Preliminary Findings from Review

of the USGS Study of the
Cuyama Valley Groundwater Basin

Cuyama Basin Water District

27 October 2017 | EKI B70069.00

Figure 5

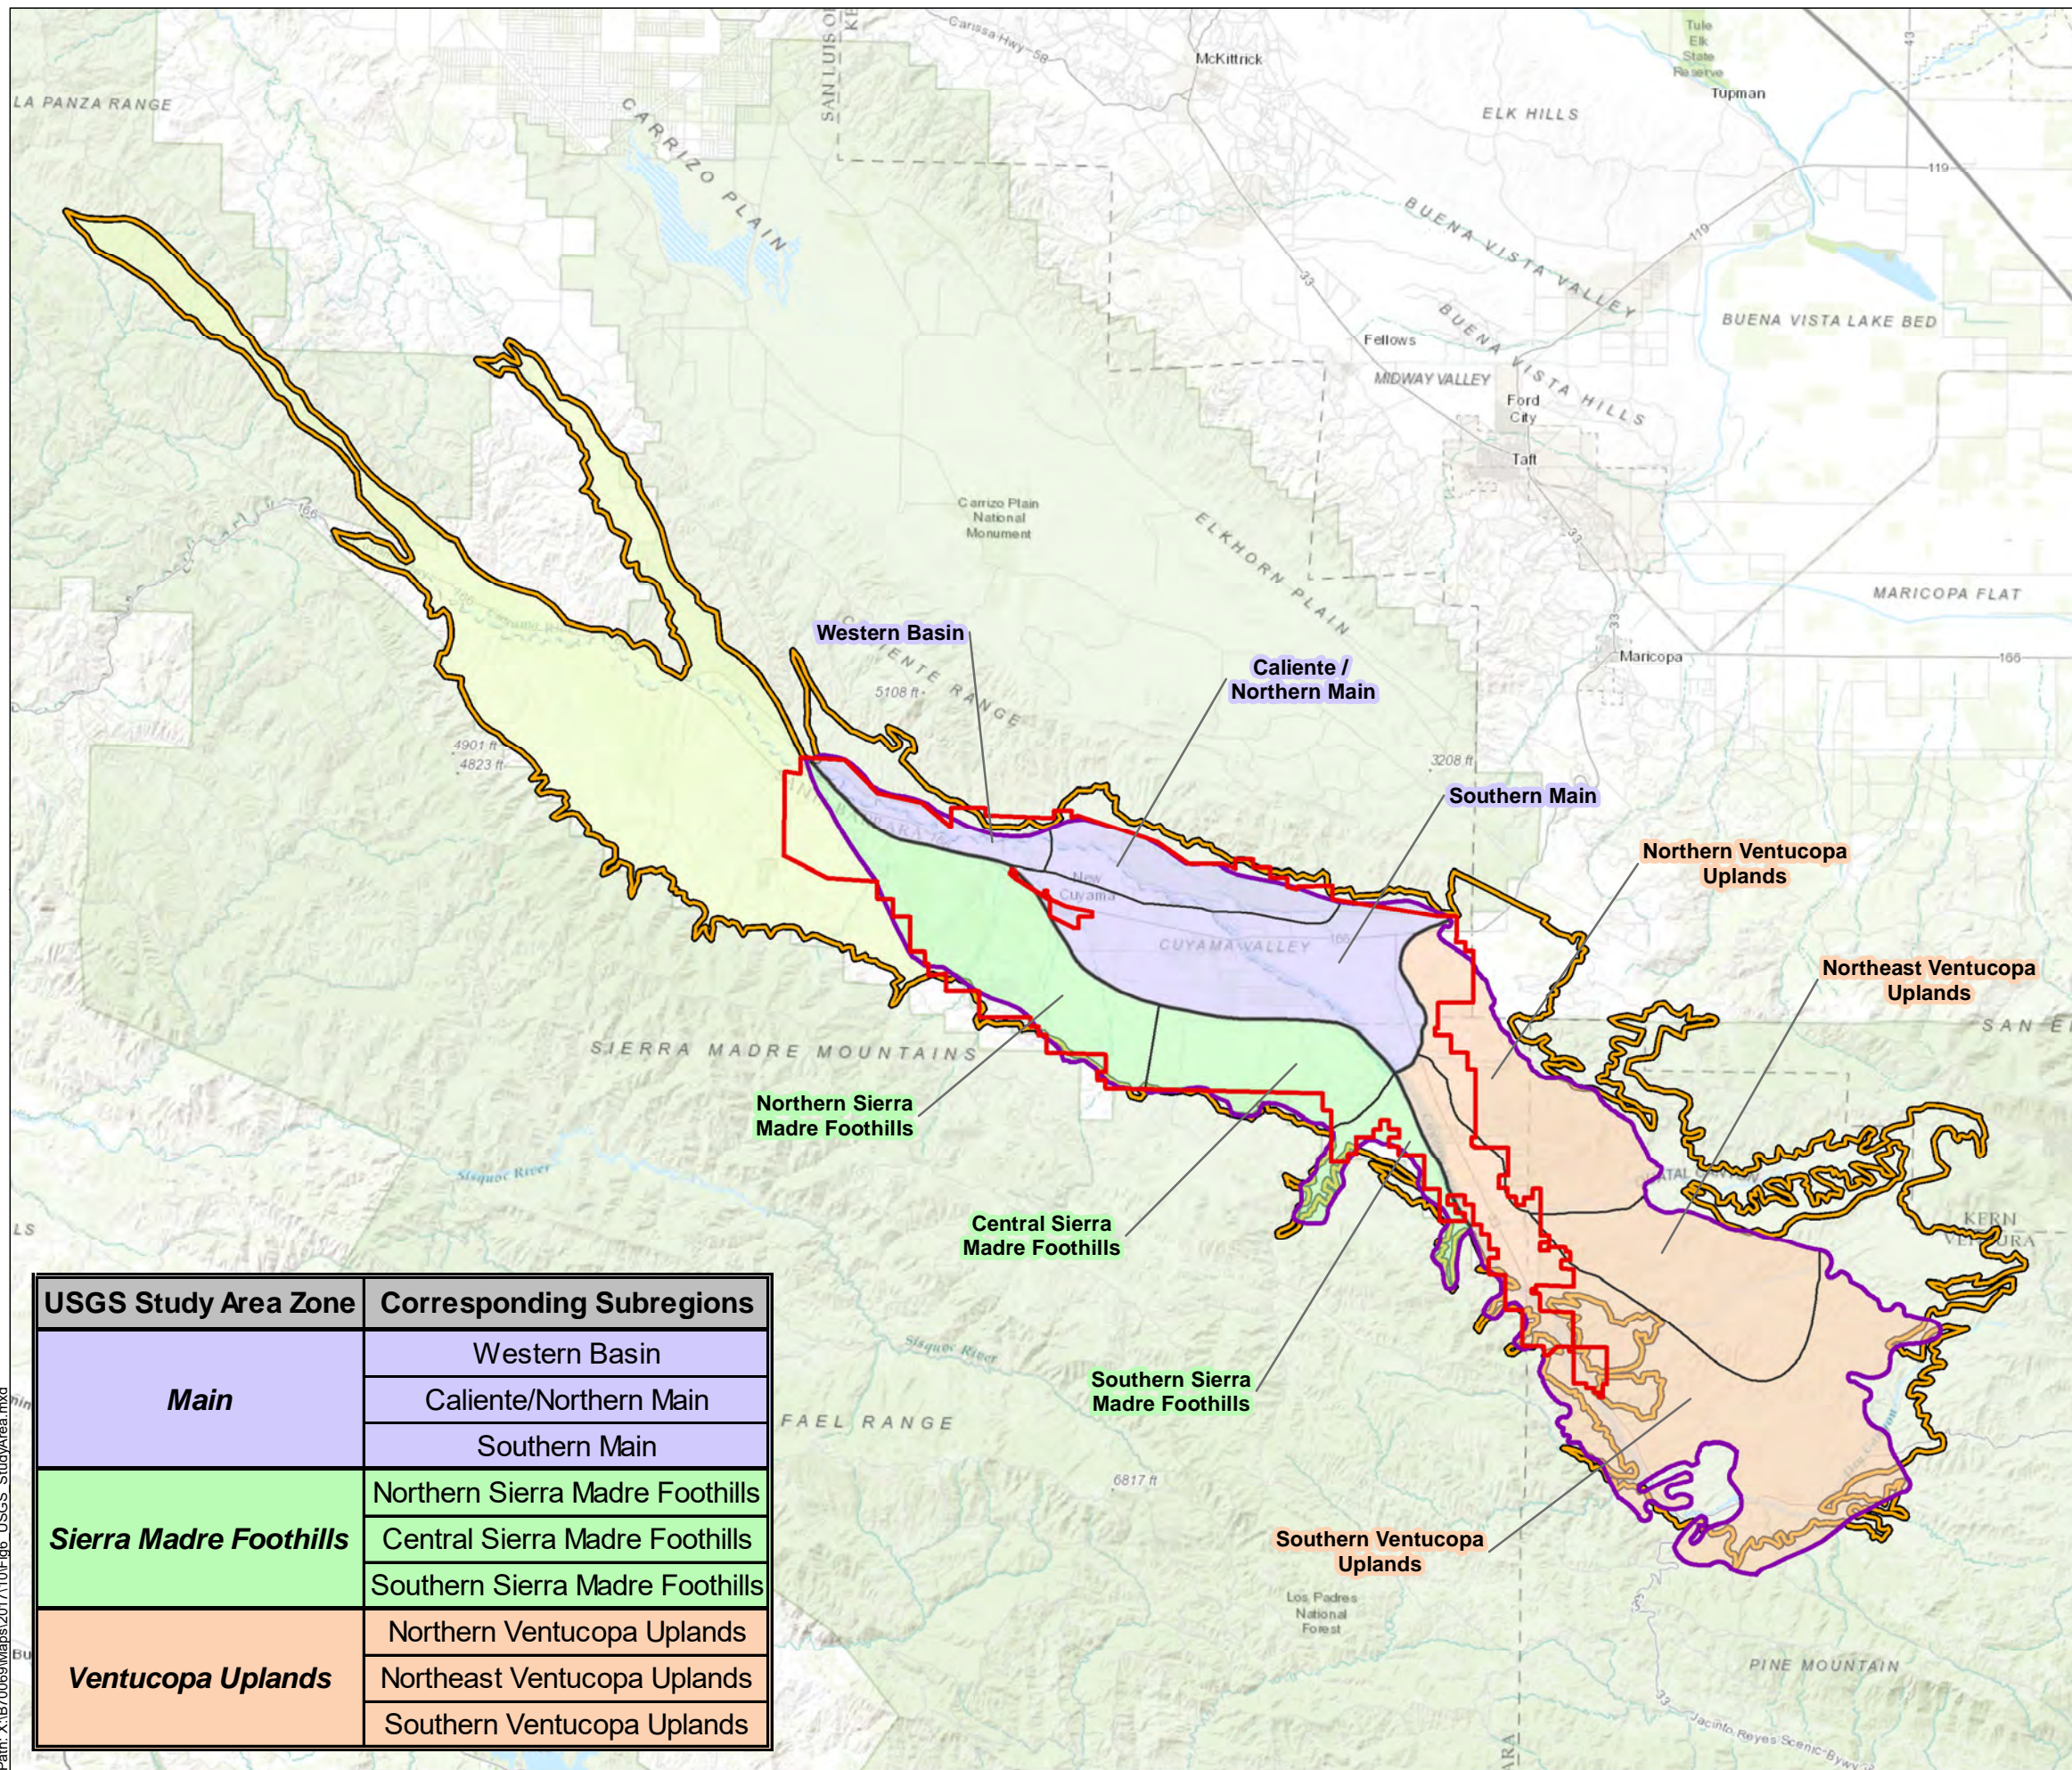
Cuyama Basin that lies within Kern County. Most significantly, on the northwestern side of the basin, the entire portion of the basin that lies to the west of the approximate surface trace of the Russell fault is excluded (see Figure 5). This area to the west is referred to herein as the “Cottonwood Creek” area¹². In total, the USGS Study Area only includes approximately 61% of the DWR-defined Cuyama Basin.

Figure 6

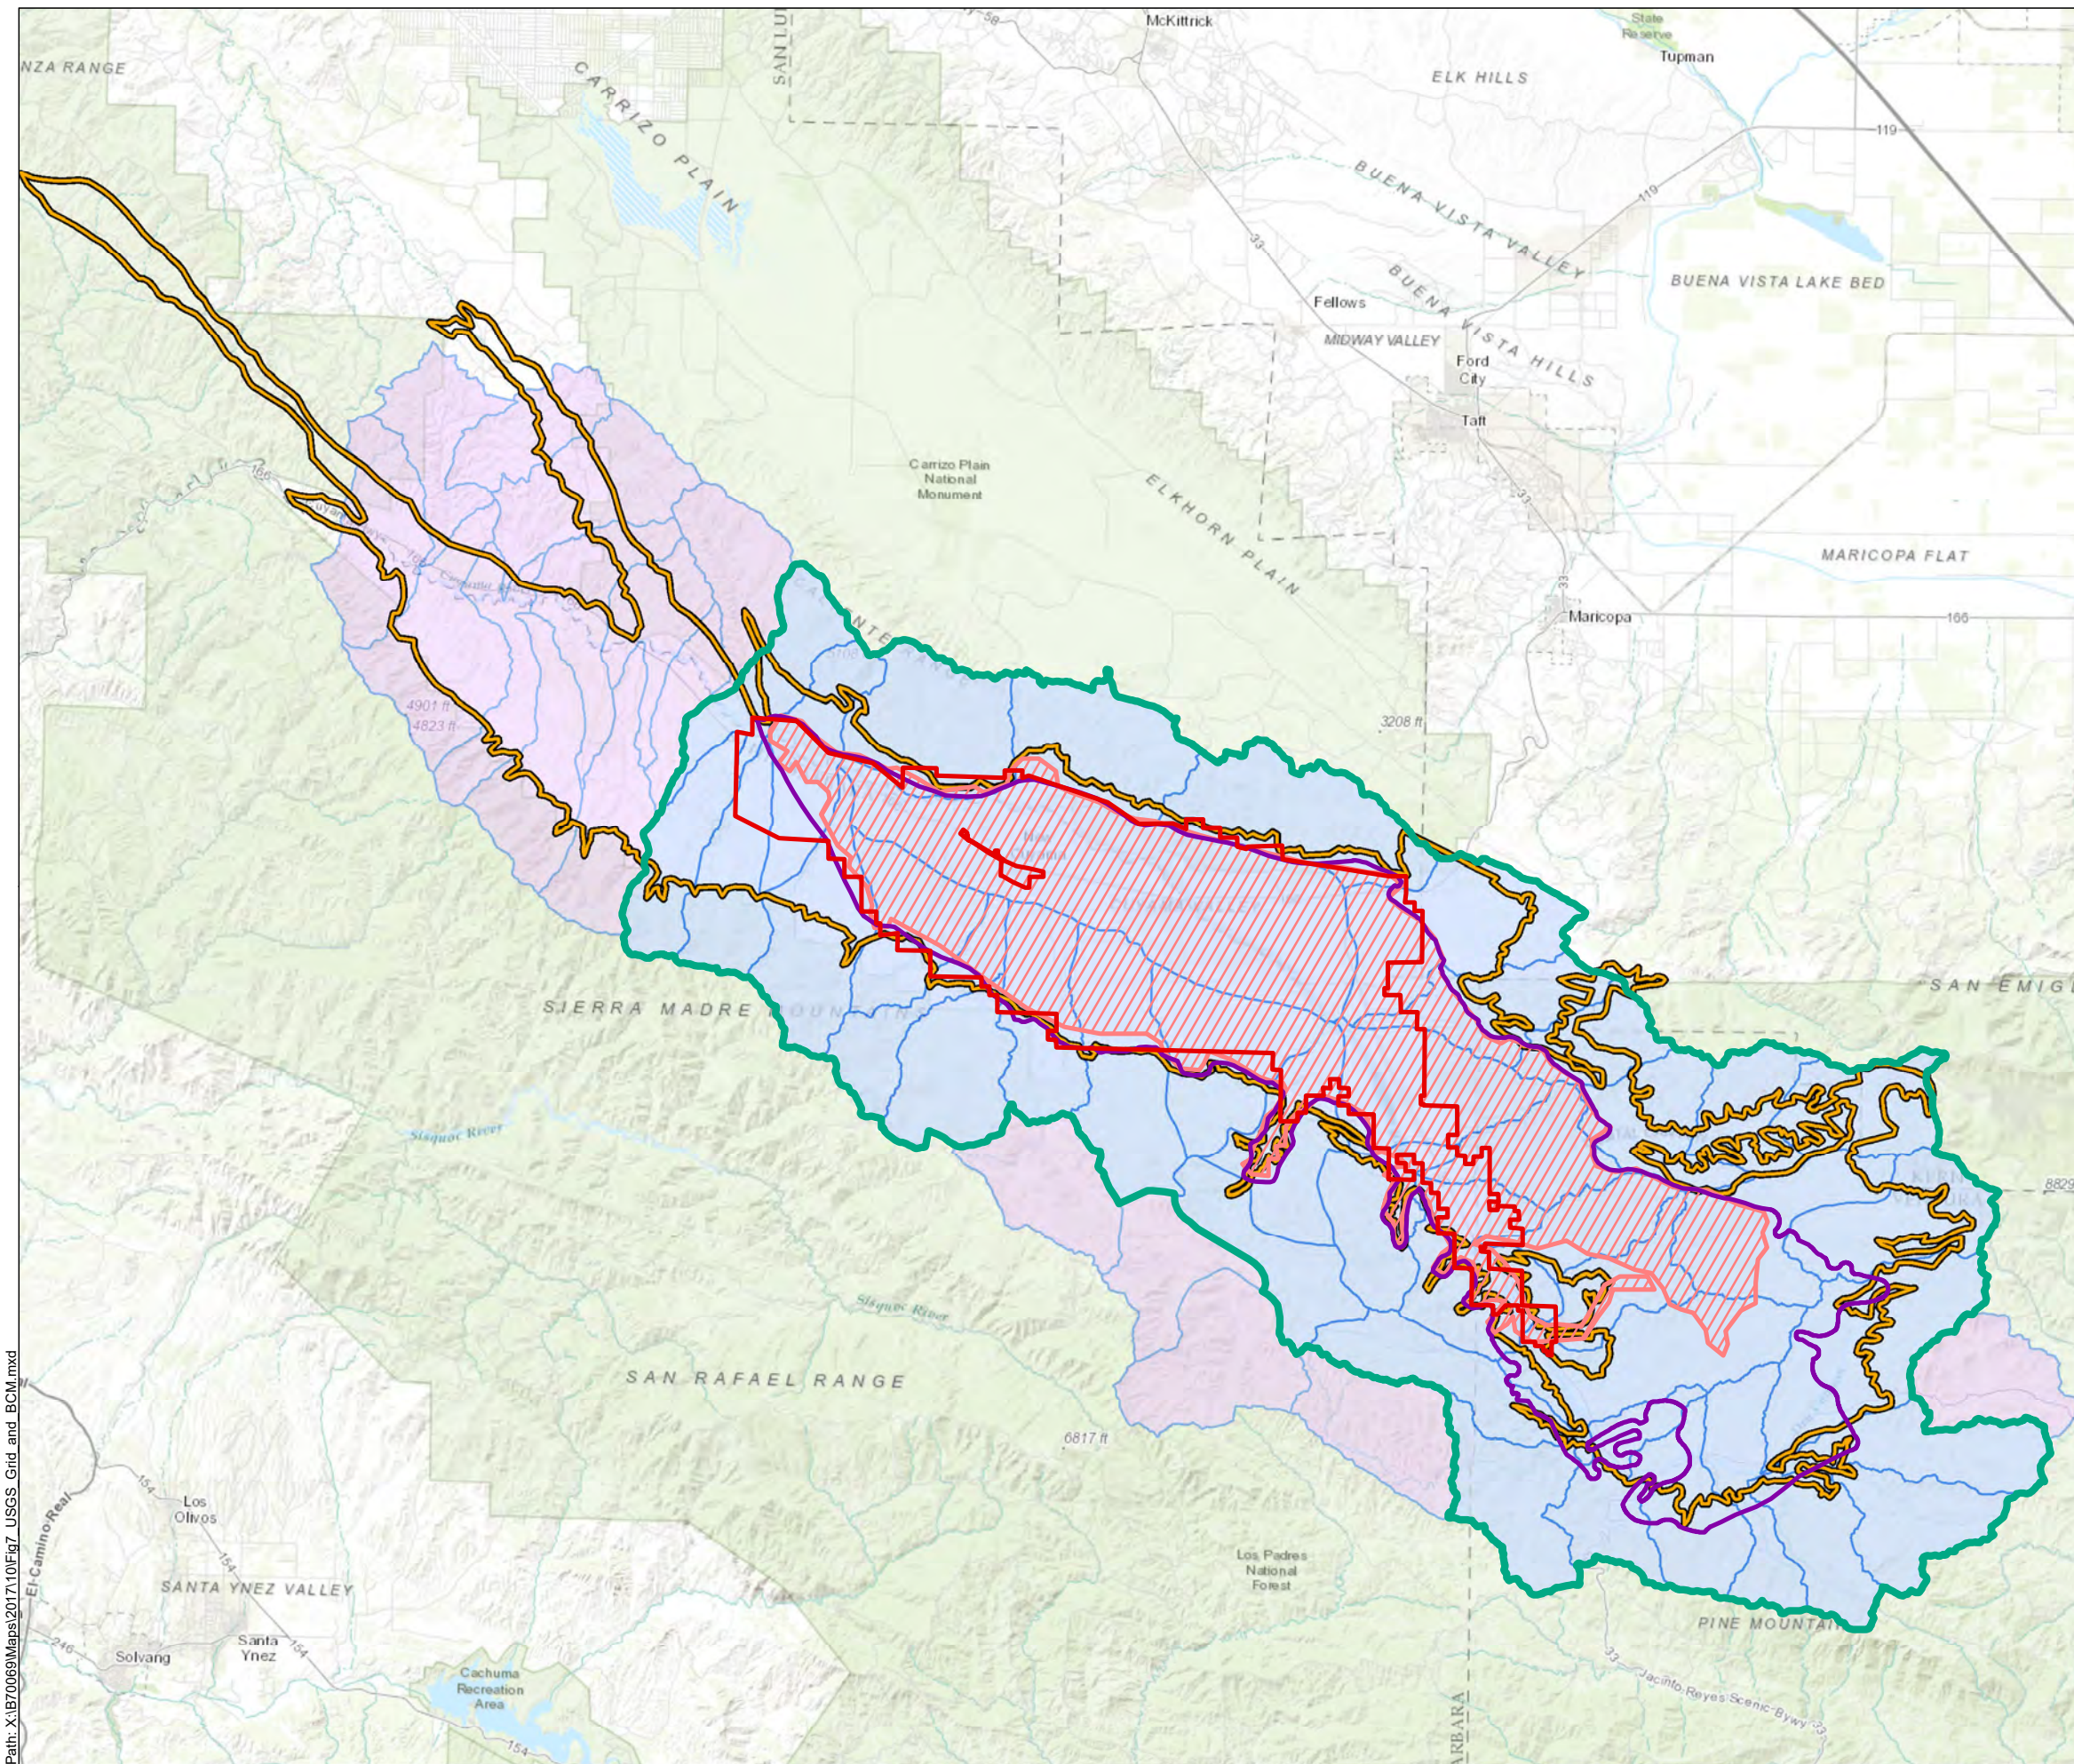
The USGS Study, however, focuses on what the USGS has separately delineated as the “Cuyama Groundwater Basin” which includes a portion, but not all, of the DWR-defined Cuyama Basin (see Figure 6). For the purposes of this memorandum, we refer to the area considered in the USGS Study as the “USGS Study Area”. Furthermore, and as discussed further below, the USGS Study includes the BCM and CUVHM whose spatial domains are different from, and a further subset of, the USGS Study Area (see Figure 7). Herein we refer to those spatial domains as the “BCM Area” and the “CUVHM Area”, respectively.

As shown on Figure 6, the USGS divided the USGS Study Area into three groundwater basin “zones” – the “Main zone”, the “Sierra Madre Foothills”, and the “Ventucopa Uplands” – and then further subdivides those three zones into nine “hydrologic subregions”. The USGS states that the reasons for these subdivisions are that they: (a) “are fault bounded”; (b) “represent different proportions of the three alluvial aquifer systems”; (c) “have different water-quality characteristics”; and, (d) are defined “where the response to the use, movement, and consumption of water is similar in specific parts of the aquifers but differ from the response in the other subregions” (Hanson et al., 2014). The USGS further states that the Cuyama Valley can be considered a collection of “partially hydraulically connected” subbasins with “different hydrologic features or hydraulic properties” that “respond differently to natural and anthropogenic stresses.”
